Form 3160-5
(June 2015)UNITED STATES
DEPARTMENT OF THE INTERIOR
BUREAU OF LAND MANAGEMENTFORM APPROVED
OMB No. 1004-0137
Expires: January 31, 2018**SUNDRY NOTICES AND REPORTS ON WELLS**
**Do not use this form for proposals to drill or to re-enter an
abandoned well. Use Form 3160-3 (APD) for such proposals.**

8. Well Name and No. Toles Federal #4

9. API Well No. 30-005-62480

Proposed P&A NOI
ConocoPhillips Company on behalf of M E W Enterprise
Orphan Well
Toles Federal #4
30-005-62480

PROPOSED
Wellbore Diagram

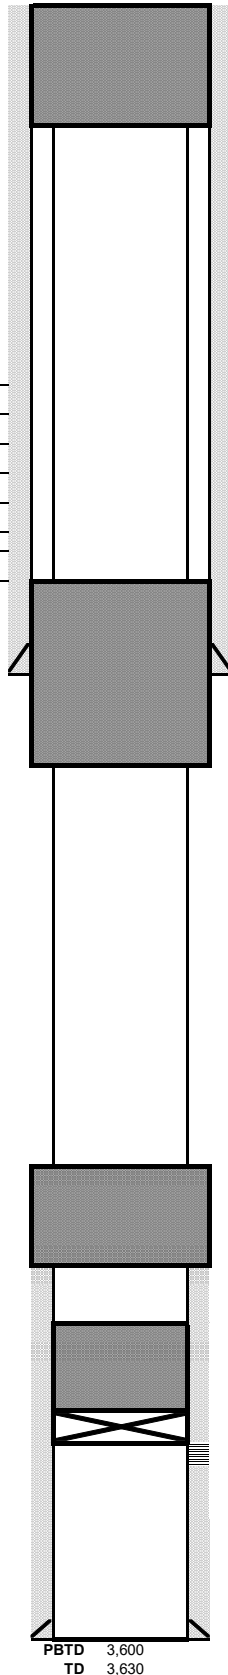
Plug #4: Perf & Squeeze 48 sxs class C cmt @ 100' & circulate to surface.
(38 sxs outside, 10 sxs inside)

Plug #3: Perf & Squeeze 127 Sxs class C cmt w/ 2% CaCl @ 1,044-765'. WOC & Tag. (Yeso, 8 5/8" Shoe, & Glorieta)
(105 sxs outside, 22 sxs inside)

Plug #2: Perf & Squeeze 45 sxs class C cmt @ 2,380-2,280'. (Tubb)
(35 sxs outside, 10 sxs inside)

Plug #1: Set 4 1/2" CIBP @ 3,036'. Spot 25 sxs class C cmt w/ 2% CaCl @ 3,036-2,708'. WOC & Tag.

1. Operator shall place a CIBP at 3,036' (50'-100' above top perf) and place 25sx of Class C cement on top. WOC and TAG.
2. Operator shall perf 2,380' and squeeze class C cement to 2,280' to seal the Tubbs as proposed. WOC and TAG.
3. Operator shall perf at 1,044' and squeeze class C cement to 765' to seal the Yeso Formation and the 8-5/8'' shoe. WOC and TAG.
4. Operator shall perf at 100' and squeeze cement class C cement to surface.
5. Dry hole marker must be below ground.
6. Surface reclamation will need to be completed once the well bore has been plugged. Please contact rflores@blm.gov for additional information.
7. See attached for general plugging stipulations.
8. See attached for New Mexico Oil Conservation Division's plugging guidelines.
